**Observations on the Report of Dr Stephen Buss
Grove Lodge: Modelling impact of basement development
on groundwater (20/01/2016).**

1. The report on modelling was commissioned by Campbell Reith in their capacity as the independent adviser to The London Borough of Camden's planning department and used to assist the Planning Committee with their decision on the application for the development of Grove Lodge (2015/4485/P & 2015/4555/L), taken on 21st January 2016.

FIG 1 (MARCH 2016)

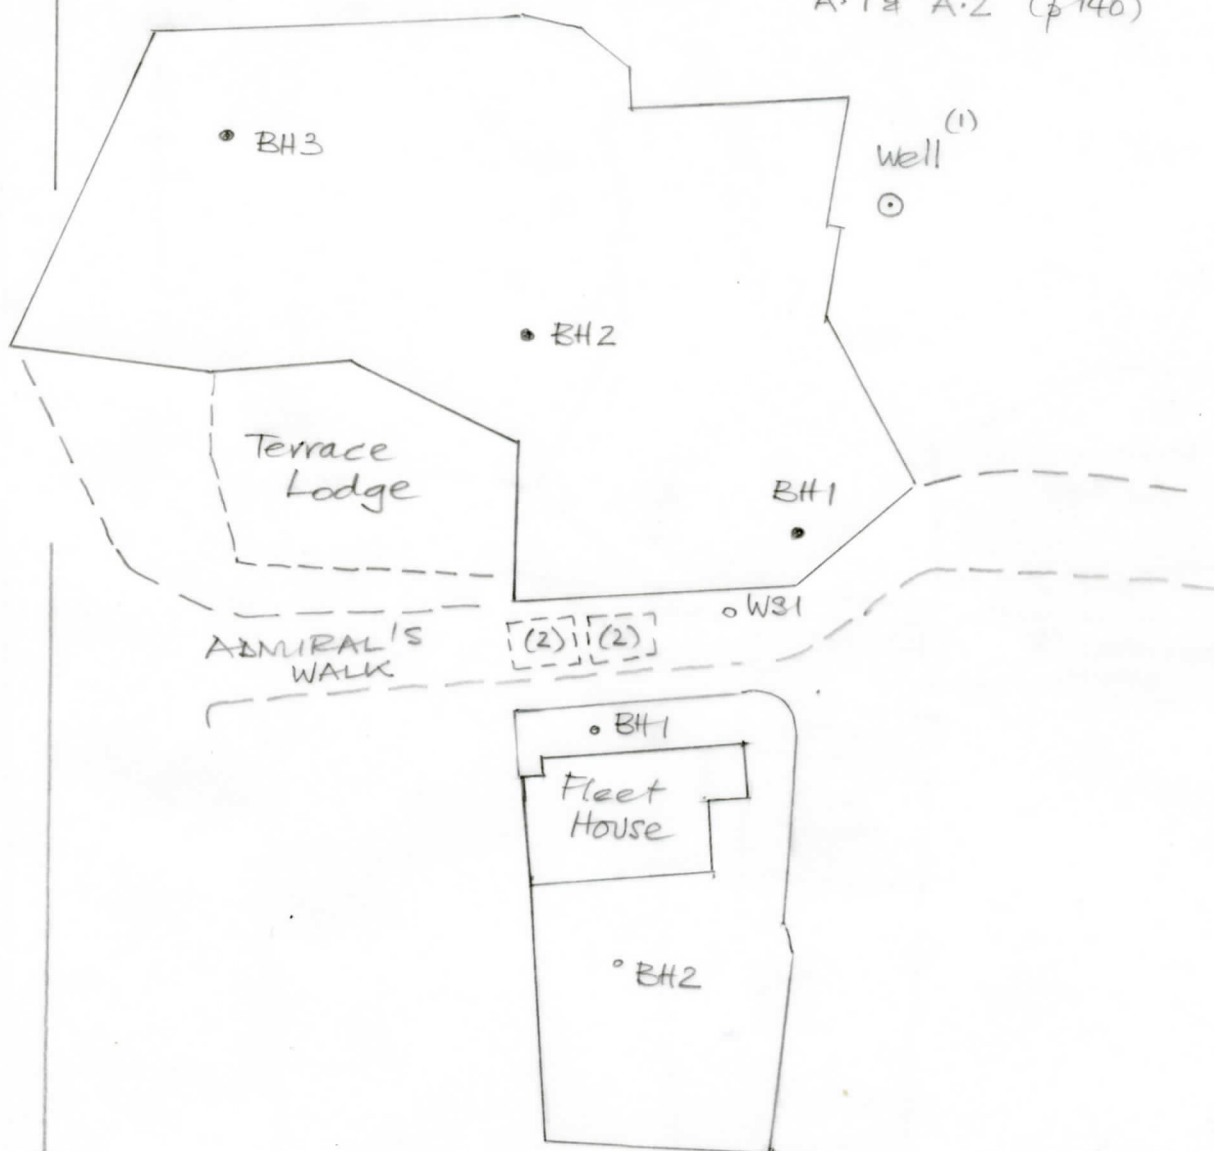
14. In an attempt to understand this further First Steps has completed a very simple analysis illustrated by two figures; Fig.1 (March 2016) shows the relative positions of the available data points and Fig. 1A a simple triangulation of water levels chosen as follows:

- i) BH3 offers no choice, there is only one level, 123.19m
- ii) The well has a range of levels which can be seen; a mid-level between the highest seen and the level measured in August 2015 has been chosen; 123.5m
- iii) BH1 Fleet House intersected mild sub-artesian conditions and a level is taken as midway between the level where the water under pressure was struck and its piezometric level, as these two are not so far apart; 122.1m.

FIG 1A.

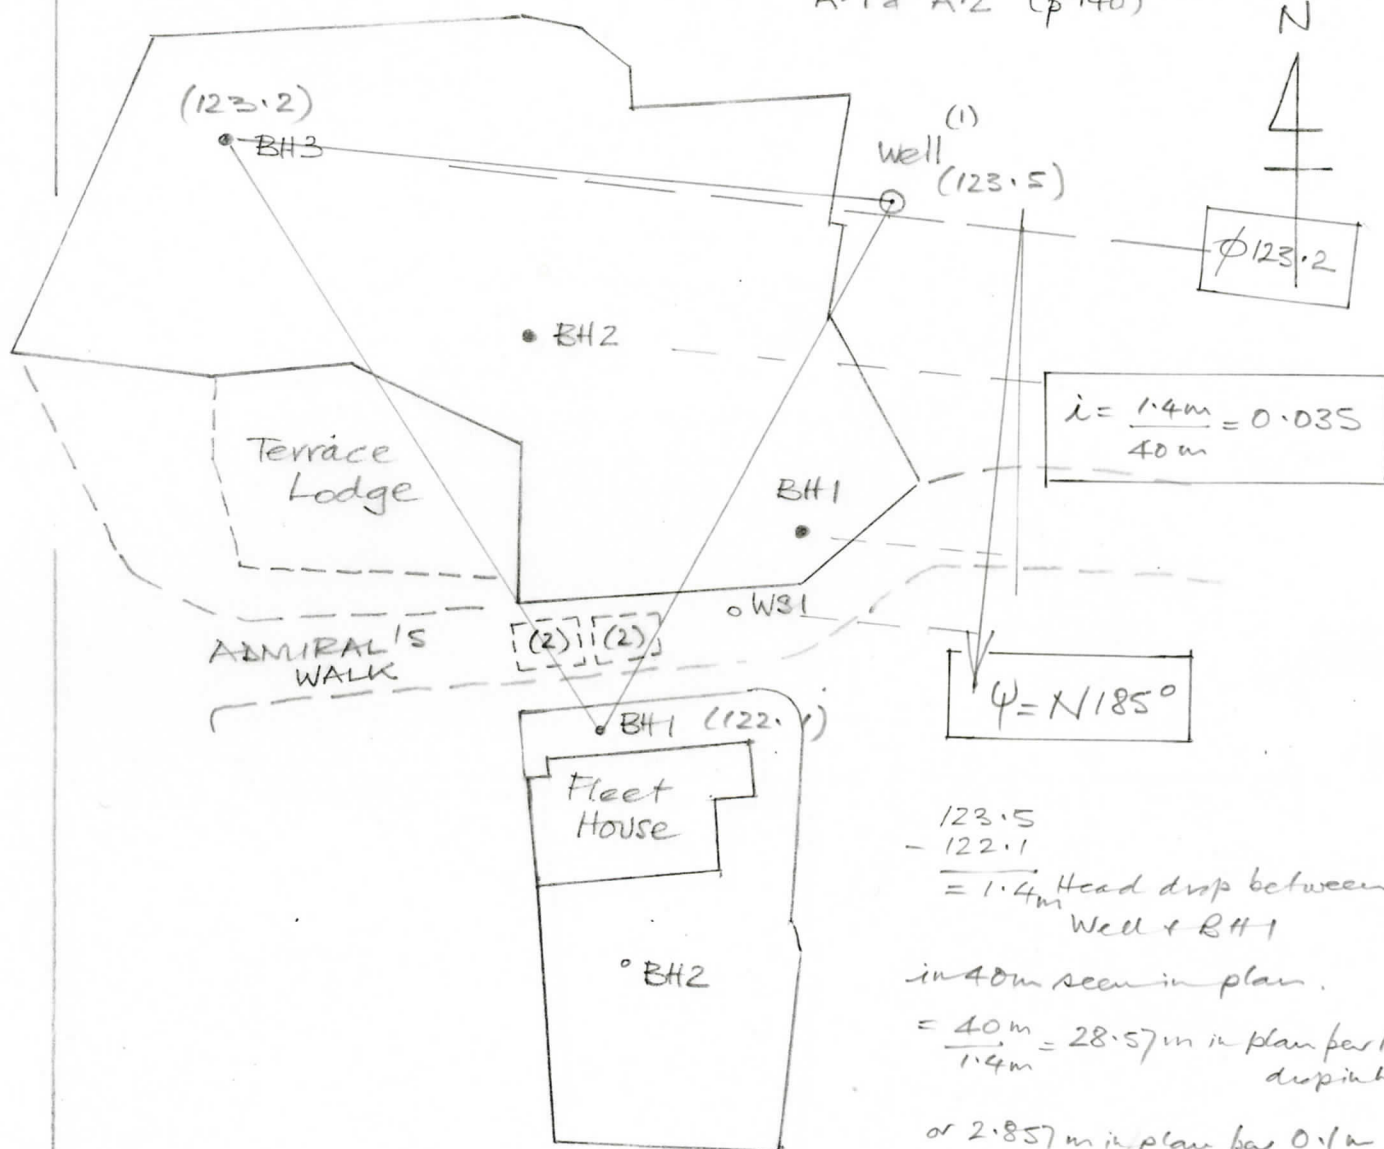
15. Despite the selection required for water levels the result of this simple analyses (Fig.1A) is a North – South flow (which would be expected from the topography and the geology) with an hydraulic gradient of 0.035 (which is an order of magnitude better for these materials than 0.1 generated from the modelling work) and a pattern of flow that remains in the superficial material above the clay (which is hydrogeologically reasonable).

16. Given that the selection of water levels could be criticised as arbitrary it is instructive to consider if this distribution of head can predict the heads in the other holes not used in the analysis, and the following if found;

For Grove Lodge BH 1 predicted = 122.72m: actual = 123.74m
For Grove Lodge BH 2 predicted = 123.1m: actual during drilling = 123.5m
For Grove Lodge WS1 predicted = 122.52m: actual (2nd reading) = 122.27m

17. Thus although the precise level of water to use in these analyses involves judgement it is reassuring to see the pattern of flow resulting from the levels used in Fig 1A reflects a judgement closer to reality than that shown by the modelling in Fig. 2.4.
